UNITED STATES
NUCLEAR REGULATORY COMMISSION
REGION III
799 ROOSEVELT ROAD
GLEN ELLYN, ILLINOIS 60137

April 28, 1976

NORTHERN STATES POWER COMPANY (MONTICELLO)
LICENSE NO. DPR-22 (DOCKET NO. 50-263)
COMMENTS ON THE MONTICELLO LICENSE AMENDMENTS - RADIOLOGICAL
ENVIRONMENTAL MONITORING PROGRAM

Figure 4.3.1

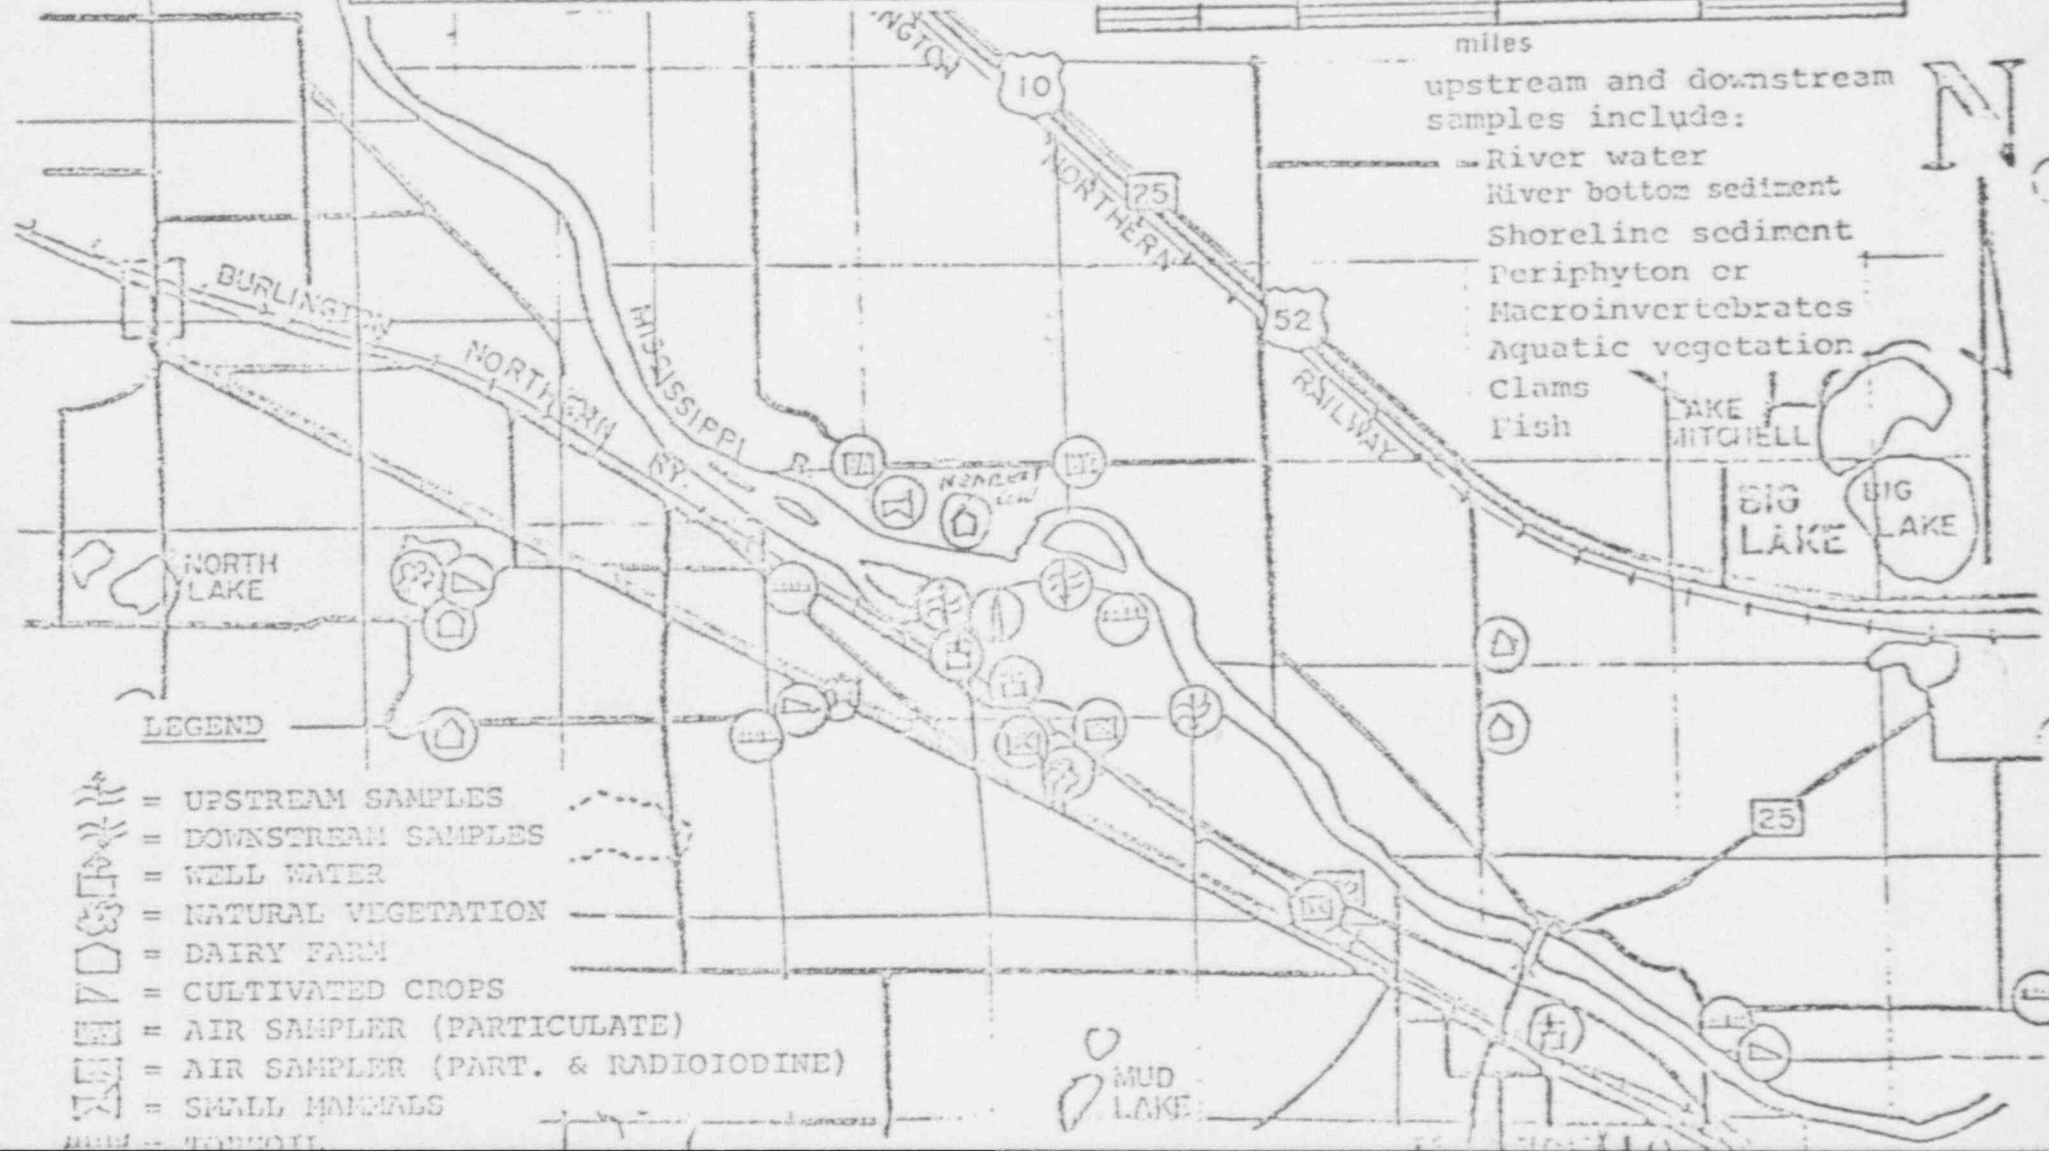
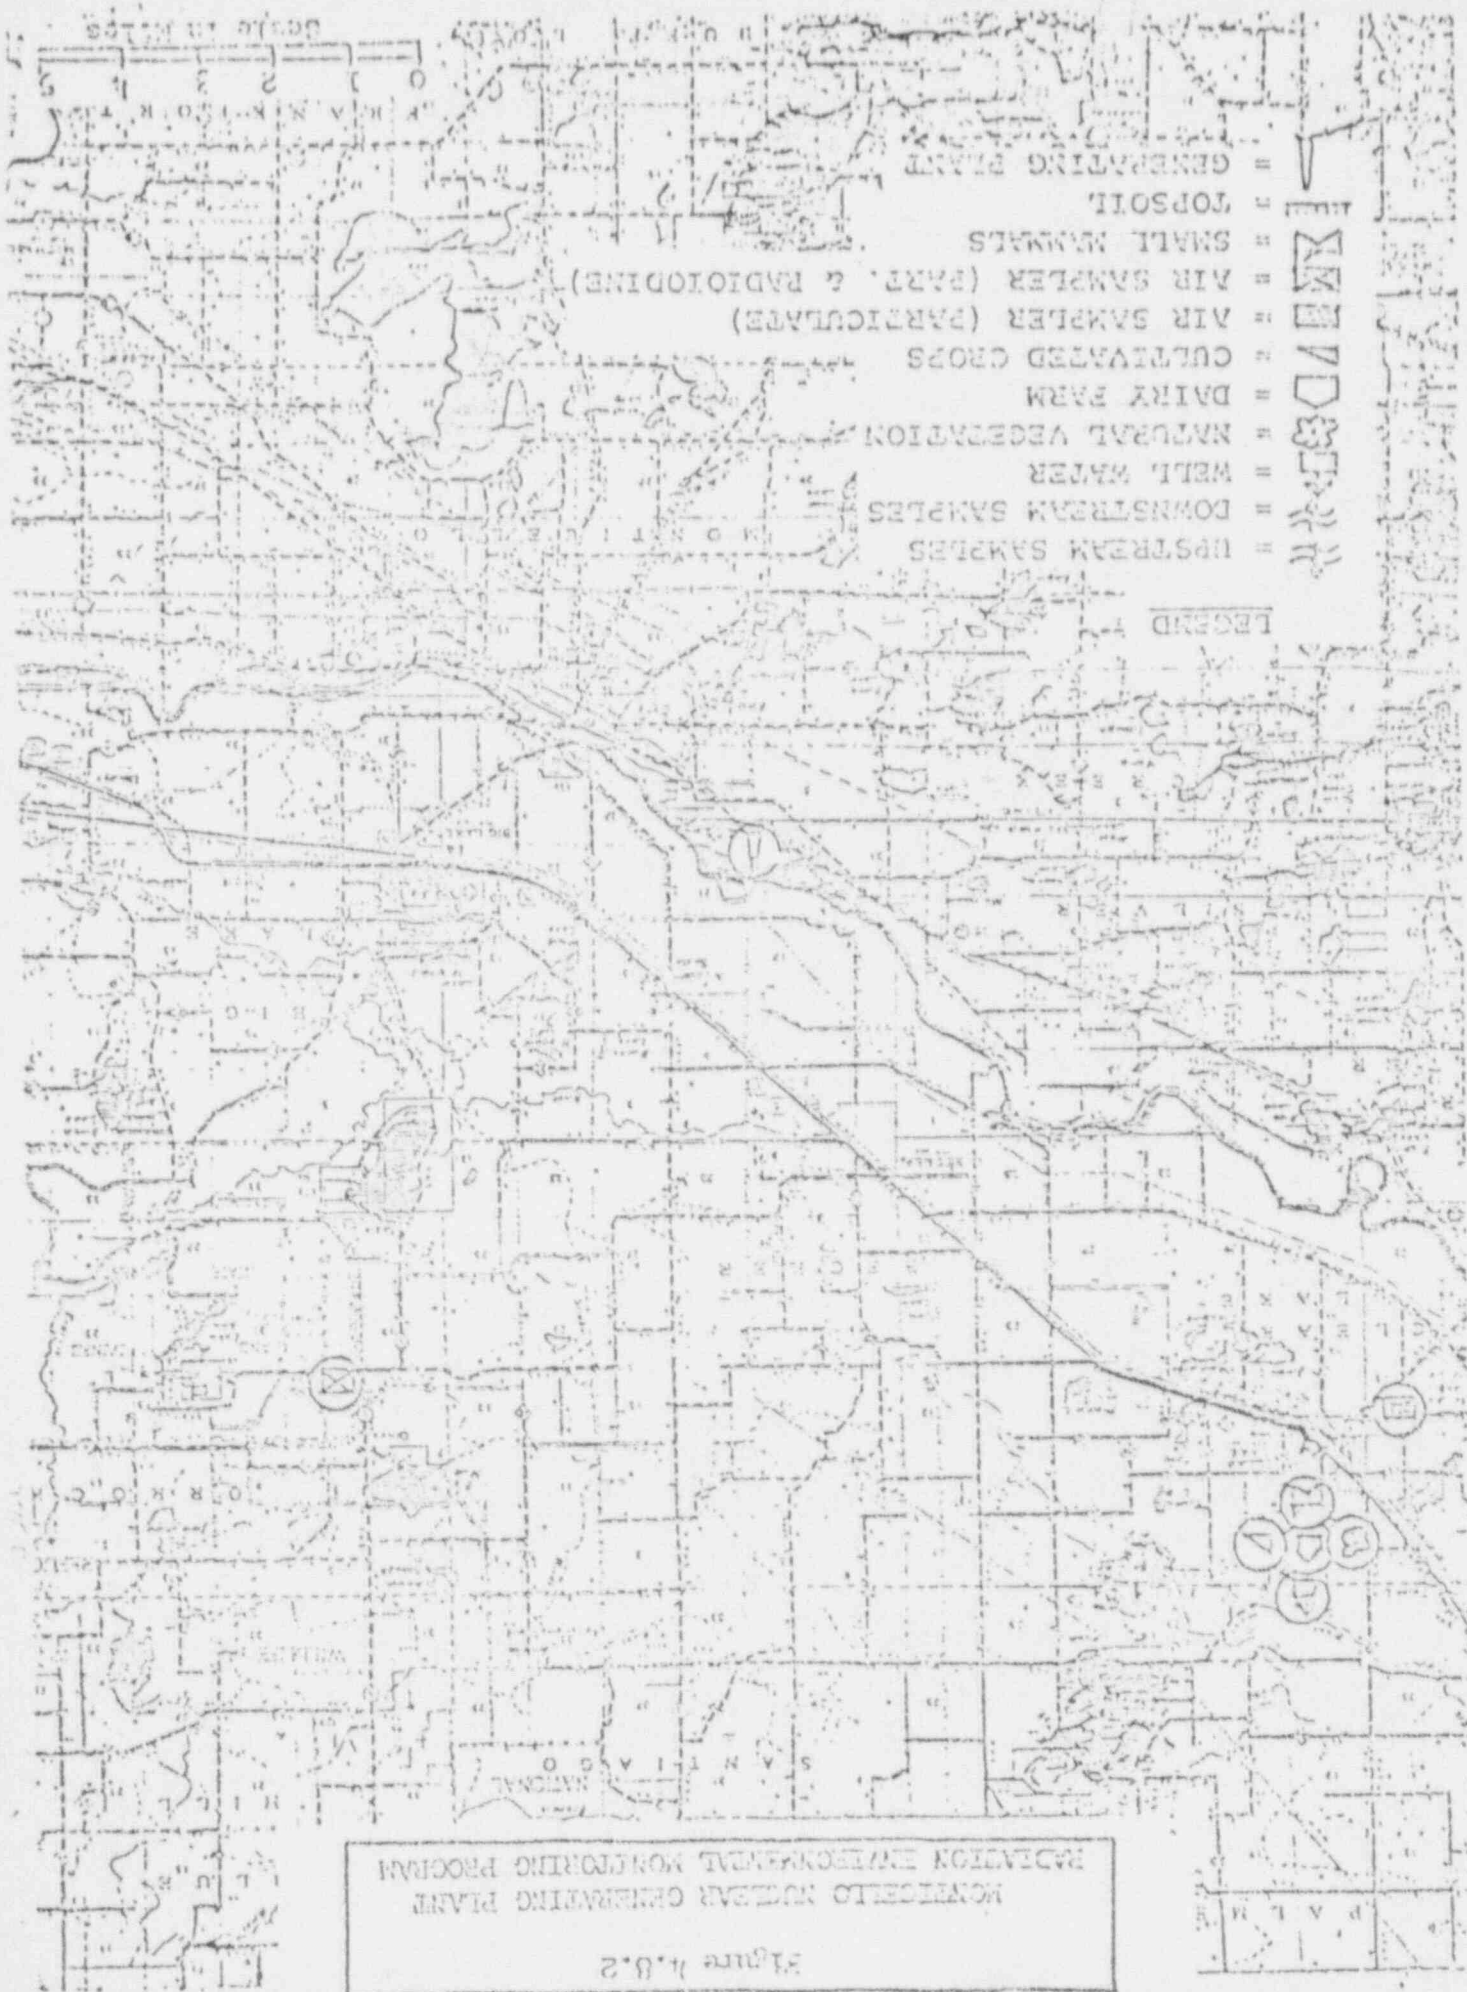
In terms of the collection site, improvements have been made in specifying sampling locations, particularly at the points of highest X/Q. However, no sampling of milk from the nearest existing milk cow (1.5 miles NW of the plant) (FES. p. V-30) is being done by the licensee or included in the proposed license amendment. Furthermore, no sampling is done of river sediment and indicator organisms in the immediate downstream area of the discharge point.
